Subject: EGR System

**Application: 900 Turbocharged models with EGR
1990–1992**

CATEGORY	
Engine	
SECTION 2	PAGE 24
ISSUE 10/92–0264	CODE 254

Figure 1. Removing EGR Valve Retaining Bolts

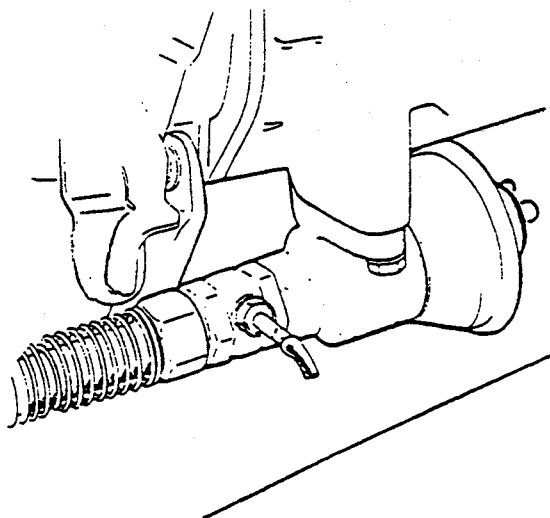
1. Remove the EGR valve retaining bolts and remove the EGR pipe from the exhaust manifold. Lift out the valve and pipe (figure 1).

Plug the pipe connection in the exhaust manifold by means of threaded plug P/N 81 23 739 and replace the EGR valve with plate P/N 93 58 177, gasket P/N 75 07 973 and two bolts 80 19 887.

Figure 2. Removing Modulating Valve & Hoses

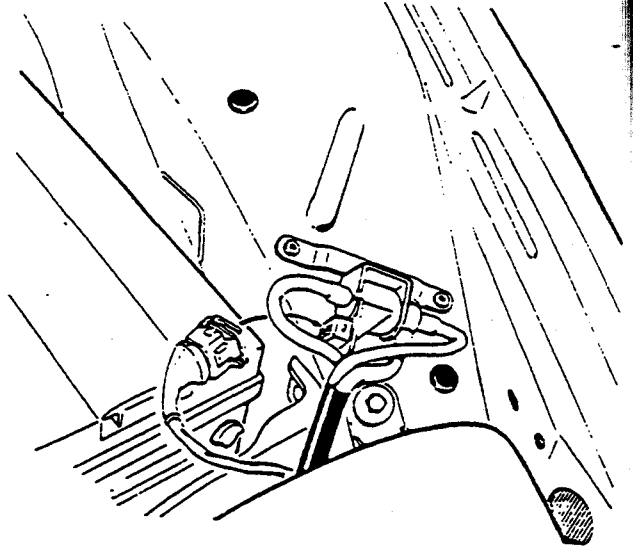
2. Remove the modulating valve and vacuum hoses (figure 2).

Figure 3. Vacuum Tank and Vacuum Hoses

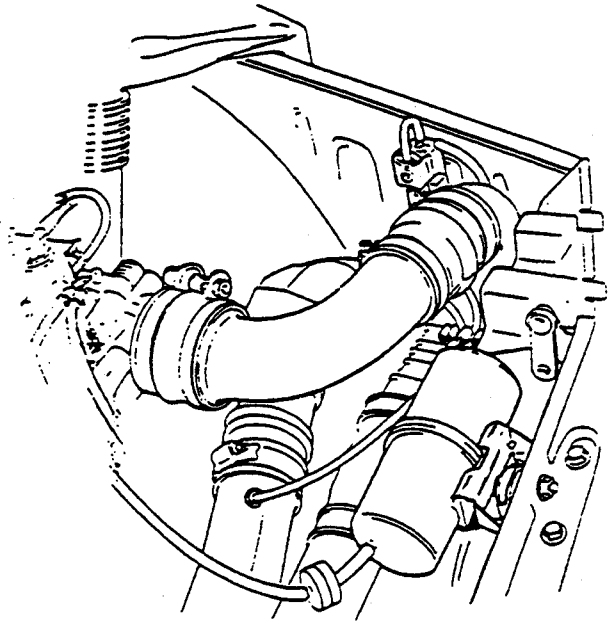
3. Remove the vacuum tank and its vacuum hoses. Plug the hose connection on the intake pipe and the nipple on the pressure pipe by means of rubber plug P/N 83 35 614 (figure 3).

Figure 4. LH ECM

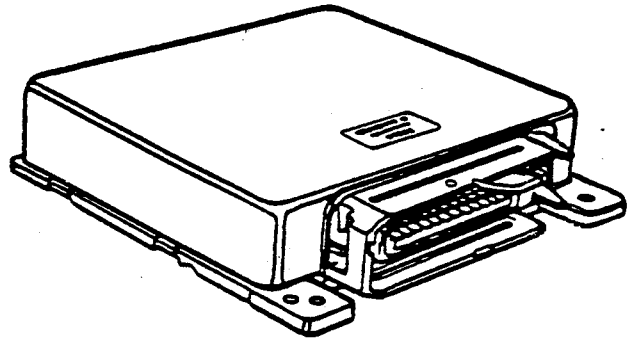
4. Fit a new LH ECM, P/N 02 42 172 (see figure 4).

Figure 5. Affixing New Label

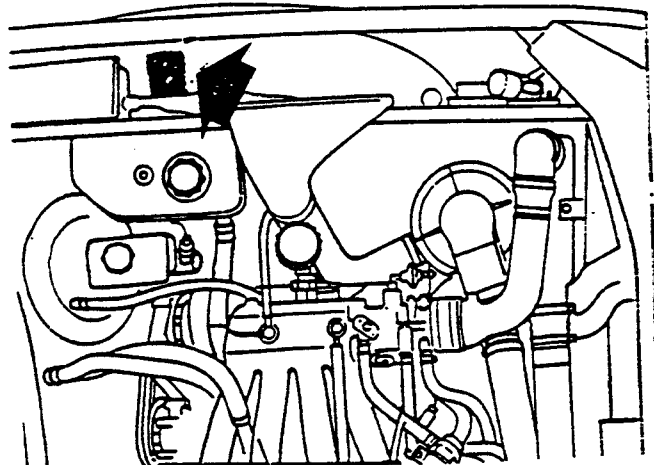
5. Remove the existing emission control label (using a heat gun) , clean the surface and affix a new emission control label on the left-hand inner fender in front of the fuse box (figure 5).
6. Test drive the vehicle, ensuring that all systems are operational.
